Subject: Certificate of Compliance Revision Request  
SPEC-150 Transport Package, Certificate Number USA/9263/B(U)-96

**SUPPLEMENTAL RENEWAL APPLICATION**  
**for**  
**NRC CERTIFICATE OF COMPLIANCE**  
**USA/9263/B(U)-96**

**Model SPEC-150**  
**Type B(U) Radioactive Material Package**

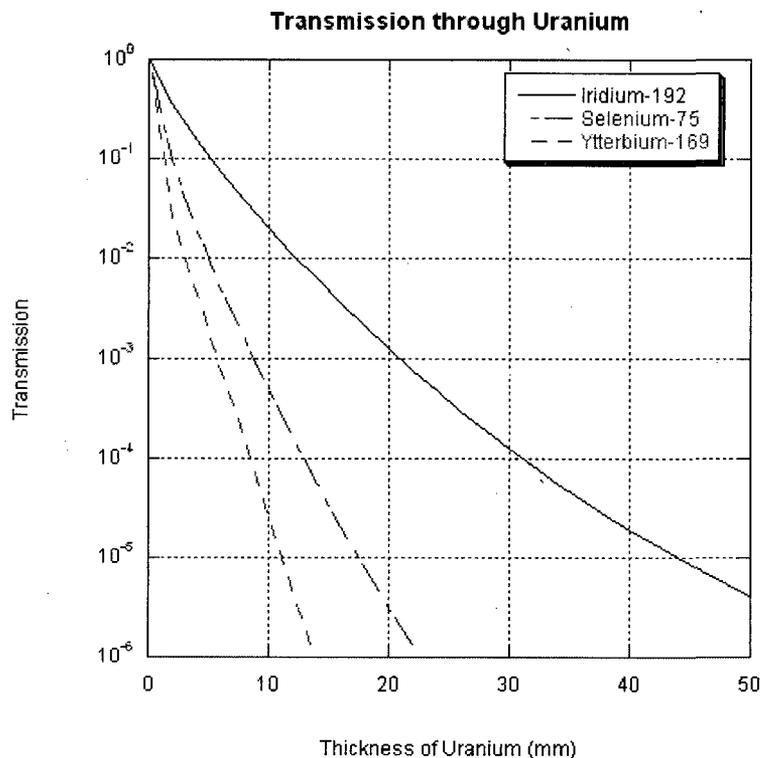
Additionally, the photon energies of <sup>75</sup>Selenium and <sup>169</sup>Ytterbium are generally lower than those of <sup>192</sup>Iridium. Therefore, the photons from <sup>75</sup>Selenium and <sup>169</sup>Ytterbium are more greatly attenuated by a given thickness of shielding than the photons of <sup>192</sup>Iridium. The attached figure shows the relative transmission of photons from each of these radionuclides through Uranium:

This demonstrates that the shielding thickness that is sufficient for <sup>192</sup>Iridium will be more efficient for the attenuation of photons from <sup>75</sup>Selenium and <sup>169</sup>Ytterbium.
